October 12, 2017

**FLAMMABLE GAS AND CRITICALITY HAZARDS
AT THE WASTE TREATMENT AND
IMMOBILIZATION PLANT**

**Defense Nuclear Facilities Safety Board
Technical Report**

June 2017

Figure 3.1. *Unmixed regions in the sparge heel and PJMs from the ZOI/CAD model for the HSLs mixing system (adapted from Appendix B of [20]).*

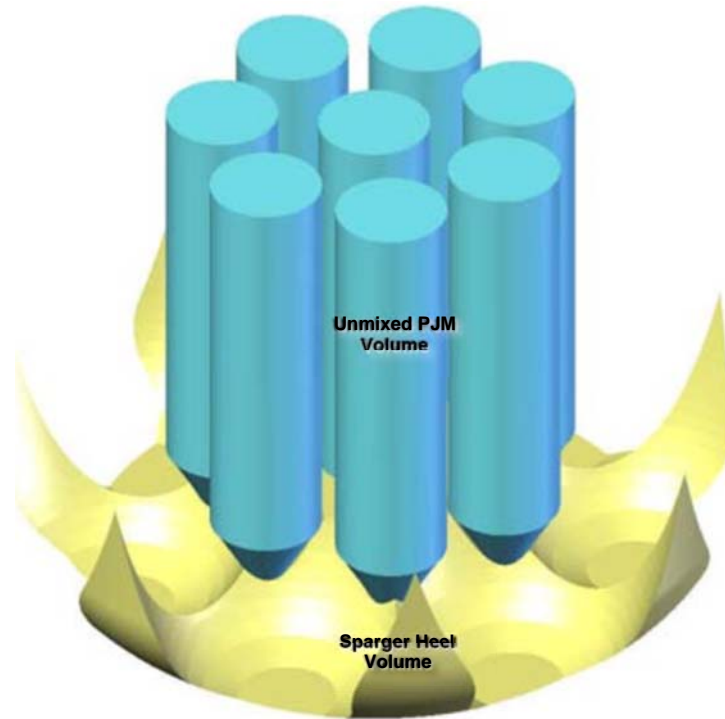
Figure 3.1 shows the result of the ZOI/CAD model for the HLS [20]. The egg-crate-shaped sparge heel (shown in yellow in Figure 3.1) results from the parabolic shape of the mobilized region predicted for each sparge tube. The HLS test vessel design had similarities to the current SHSV design. Therefore, DOE used a similar ZOI/CAD methodology to estimate the sparge heel volume in the SHSV.

The Board also notes that the relationship between the actual sparge heel volume and the volume computed using the ZOI/CAD method may not be the same for the HSLs and SHSV designs. Differences in vessel geometry, PJM layout, the number of sparge tubes, individual sparger air flowrates, and test vessel scales could potentially influence the relationship. Further, the SHSV must also operate in the high-solids Newtonian regime. The previous HSLs testing did not include sparge heel measurements with high-solids Newtonian simulants. Hence, these tests do not provide an adequate technical basis for determining the sparge heel in the SHSV for high-solids Newtonian conditions.

Measuring the sparge heel in the SHSV during the full-scale test program could eliminate the significant uncertainties discussed above and establish a conservative value for the sparge heel volume. Methods similar to those used previously in the HSLs program, such as the chloride tracer technique, could provide sufficient information to accurately determine the volume of the sparge heel.

Figure 3.2. Calculated solids loading in the settling solids layer in the FRP-02 vessels as a function of solids layer height. Shown also for comparison are three of the high-solids vessels using the SHSV design.

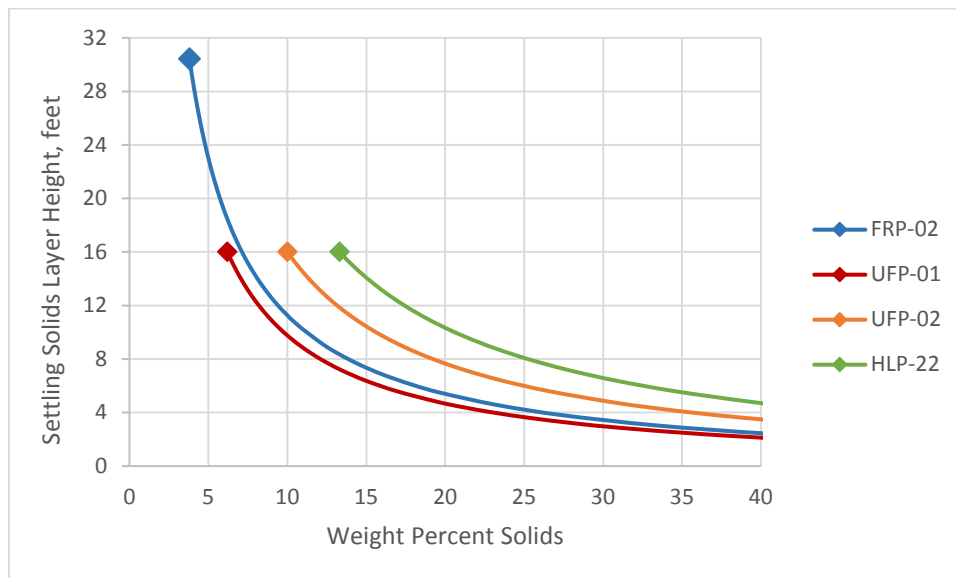
Figure 3.2 also shows two additional high-solids Newtonian vessels: the ultrafiltration feed vessels UFP-VSL-00002A/B and the HLW feed receipt vessels HLP-VSL-00022A/B/C. These vessels have solids loadings of 10, and 13.3 weight percent, respectively [27]. The vessels that use the SHSV design are filled to nominally 16 feet. Note that when the solids in the FRP-VSL-00002A/B/C/D vessels have settled to 16 feet, the settling solids layer has an average solids loading of 7.0 weight percent, a value within the range of the SHSV vessels. As settling continues, the solids loading within the settling solids layer continues to rise. After loss of mixing in the FRP-VSL-00002A/B/C/D vessels, the solids loading in the settling solids layer is sufficiently high to retain hydrogen, similar to the SHSV vessels.

The SHSV design incorporates sparge mixing to prevent unsafe hydrogen accumulations, whereas the FRP-VSL-00002A/B/C/D vessels do not have this capability. The hydrogen control strategy for low-solids vessels identified a SAC that ensures the FRP-VSL-00002A/B/C/D vessel waste level remains below an identified threshold [15]. The reduced waste level creates additional headspace that allows for the time-to-LFL to increase. DOE and BNI are also considering physical modifications to these vessels to lower the vessel overflows to ensure the

waste level does not exceed the threshold value. Because limiting waste volume is the primary control for preventing a flammable headspace, the technical rigor underpinning this SAC on vessel level is vital.

BNI documented the technical basis for the SAC on vessel level in Appendix K of the engineering study [15]. The BNI analysis models gas generation and build-up in a settling solids layer, and calculates the time to accumulate sufficient hydrogen in the solids layer to reach the LFL in the headspace for the instantaneous release of hydrogen. The analysis contains several modeling assumptions that may be non-conservative. In particular, the Board notes three areas where the analysis may be non-conservative:

- The BNI analysis assumes the solids settle to a thin layer, which may not represent the conservative case for total hydrogen generated.
- The BNI analysis assumes the solids layer settles exponentially, and that most of the settling occurs in the first 300–400 hours. A slower settling rate would provide more time for hydrogen to be generated and retained as the solids layer settles.
- The BNI analysis assumed the unit hydrogen generation rate (UHGR) varied linearly between the value reported in the WAC [10] for the fully mixed vessel and a higher value derived from a heat transfer analysis for a stationary solids layer [17]. This may not be conservative based on the spatially and temporally changing solids distribution and the evolving heat transfer boundary conditions.

Figure 3.3. UHGR at 1,000 hours versus settling fraction from the Board's calculations (Appendix B) and the linear assumption used in Appendix K of [15].

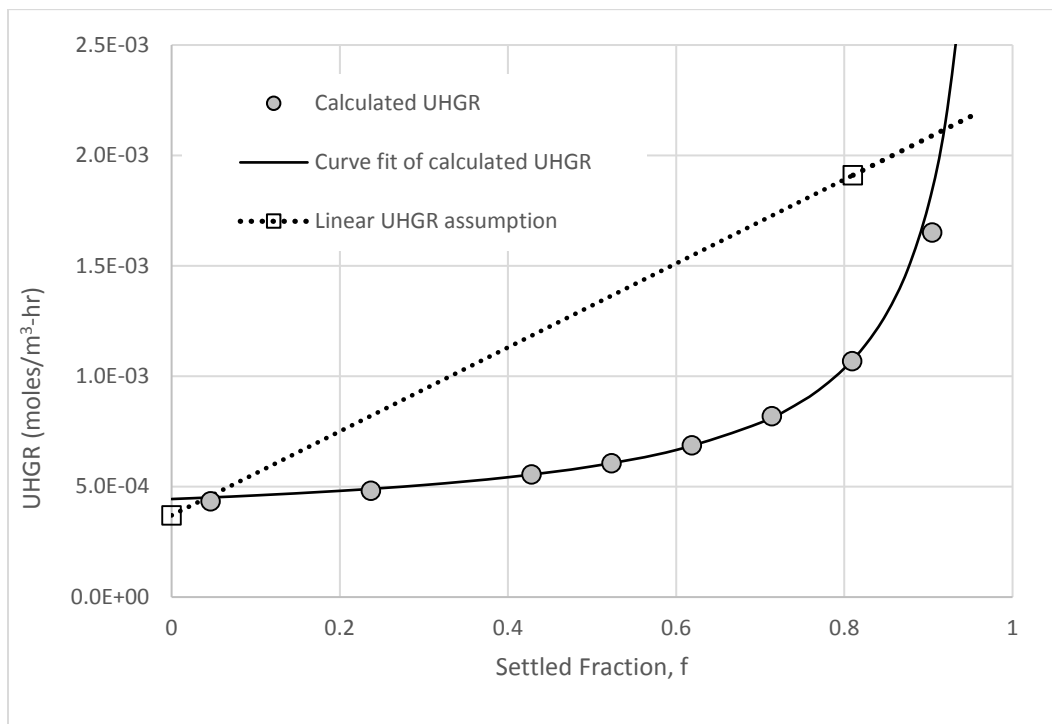
Figure 3.3 shows the results for our calculated UHGR at 1,000 hours as a function of the settled fraction. The Board obtained these results by curve-fitting the calculated UHGR values. The Board's model assumes the UHGR is only a function of the settled fraction (i.e., it is not a function of time). This assumption is conservative because it uses the final UHGR at 1,000 hours for each intermediate settling fraction throughout the settling process. This assumption is discussed further below. Figure 3.3 also shows the linear UHGR assumption employed in Appendix K of the engineering study [15]. The Board analysis incorporated both the calculated UHGR and the linear UHGR assumption.

The Board calculated the retained gas fraction in the settled solids layer after 1,000 hours. The total gas retained is the combination of hydrogen and other gases. The Board compared the retained gas fraction with the stability criteria for two different spontaneous release mechanisms: bubble cascade and buoyant displacement gas release. Bubble cascade gas release occurs in weak sludges and depends on the local yield stress. The buoyant displacement gas release requires a stratified layer and occurs when the bulk density of the lower solids layer reaches that of the liquid above it. The Board's analysis indicated that for most conditions, one or both of the stability criteria for gas release were exceeded. The main factor affecting stability is the amount of generated non-hydrogen gas. Samples from Hanford waste tanks demonstrate the fraction of non-hydrogen gas varies considerably (Appendix H of [15]). A large non-hydrogen gas fraction results in a significant amount of total retained gas. This retained gas exceeds the stability limits for spontaneous gas releases during settling in the FRP-VSL-00002A/B/C/D vessels.

Figure 3.4. Predicted headspace hydrogen concentration after a spontaneous release at 1,000 hours for both cases of gas generation variations.

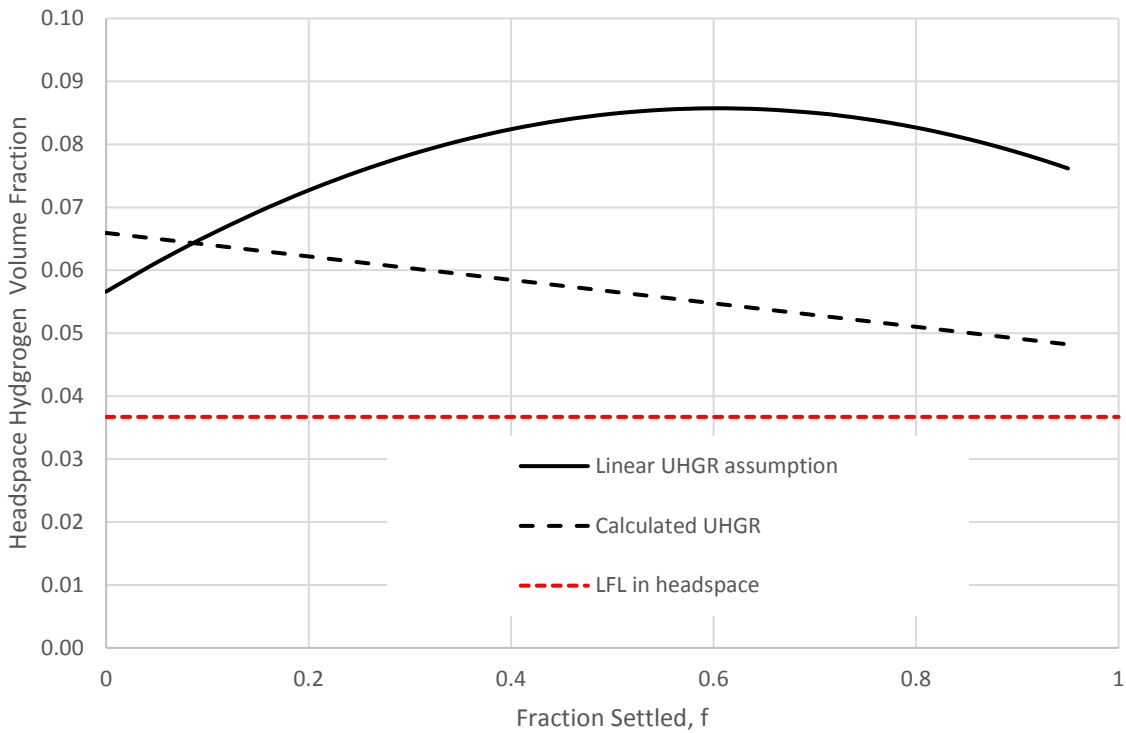
The Board's analysis calculates the hydrogen gas concentration in the vessel headspace following an instantaneous release of gas retained in the settling solids layer. Figure 3.4 shows the headspace hydrogen concentration as a function of solids settling fraction. The figure includes two cases: the calculated UHGR and the linear UHGR assumption. Also, for comparison, Figure 3.4 shows the LFL for hydrogen. Figure 3.4 indicates that the LFL is exceeded for all fractions settled for both UHGR distributions. The settling fraction, f , corresponding to the maximum hydrogen headspace concentration depends on the UHGR distribution. For the linear assumption, the maximum occurs at $f = 0.6$. For the calculated UHGR, the maximum occurs at $f = 0$ (no settling).

The Board also computed the time to reach LFL as a function of the settled fraction for different waste volumes. Table 3.4 presents the maximum values from our results for the two UHGR distributions. In addition, the table shows BNI's results. For the current maximum operating volume, the Board's analysis found the time-to-LFL was 375 hours for the linear UHGR. This is compared with 930 hours for similar conditions predicted by BNI's analysis. The main contributor to this difference is BNI's assumption of exponential settling behavior. Table 3.4 also shows the time-to-LFL for various operating volumes, including values analyzed by BNI. Reducing the operating volume not only decreases the amount of hydrogen generated, but also increases the headspace volume. Hence, the time-to-LFL increases considerably.

Figure 4.1. The solubility of sodium pentaborate at 298 K reported by Yongquan et al. [50] (blue squares) and by the WTP CSE-ES [30] (solid black line and red circles).

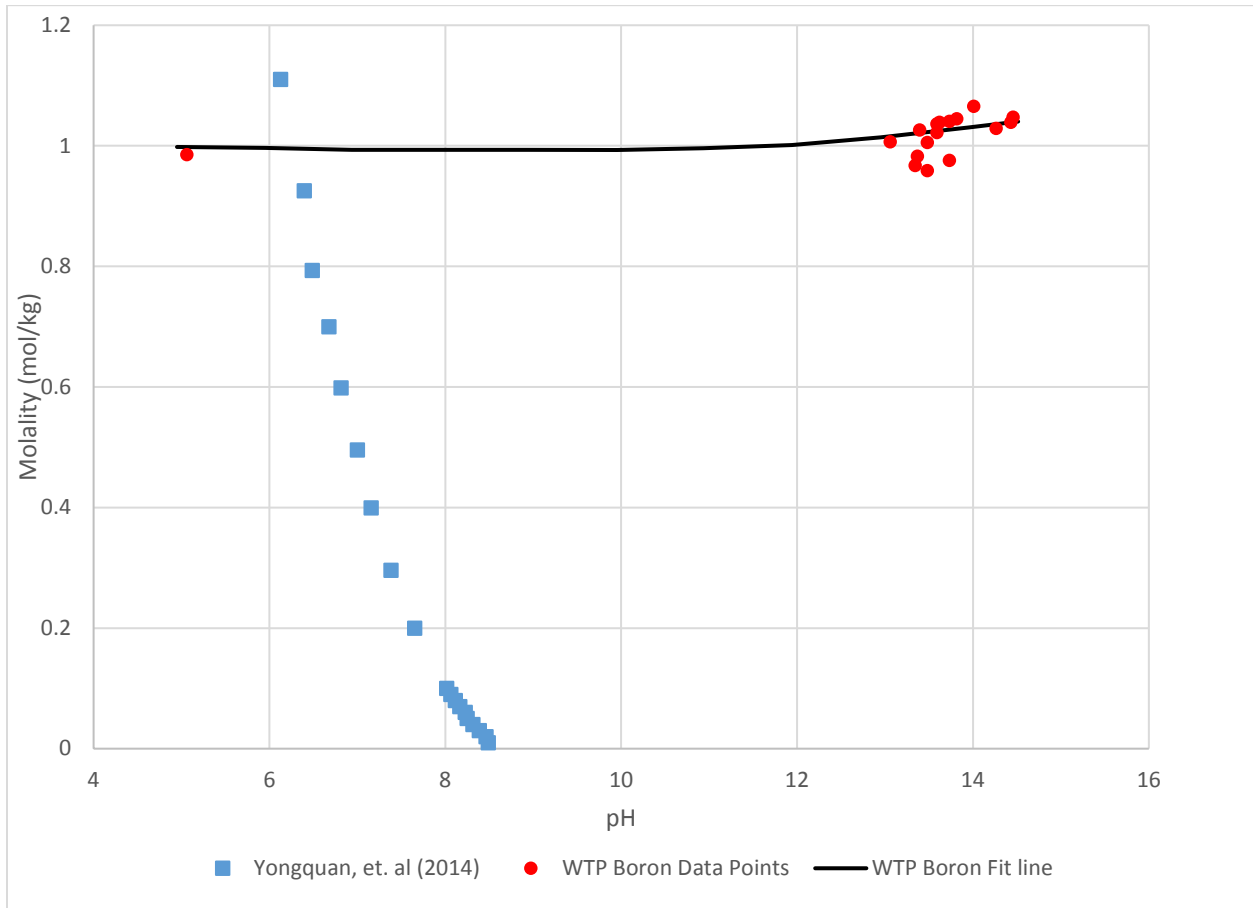
The Board also found the boron solubility used in the CSE-ES is inconsistent with solubility data available in literature [50]. The CSE-ES assumes that SPB, once introduced to WTP facilities, will exhibit the same solubility behavior as boron already present in the waste (Figure 4.1, black line). The CSE-ES also acknowledges that boron solubility needs to be

confirmed for the waste conditions in WTP. Figure 4.1 shows the CSE-ES boron solubility data and curve fit (represented by red dots and a black line) and the Yongquan et al. SPB solubility data [50] (represented by blue squares).

The boron solubility from the CSE-ES is relatively constant over a broad pH range. However, SPB solubility reported by Yongquan et al. shows a strong SPB concentration dependence on pH. Also, the CSE-ES does not specify the chemical composition of boron used to derive the data. Therefore, the assumption made by the CSE-ES that boron and SPB have the same solubility may be incorrect. [Note: The original solubility curve for boron in the CSE-ES is represented in units of molarity (mol/L), whereas the solubility data reported by Yongquan et al. is in units of molality. To provide an accurate comparison of the solubility curves for both boron and SPB (Figure 4.1), the Board converted the molarity of boron to molality using the theoretical density of 1 g/cm³ for water.]
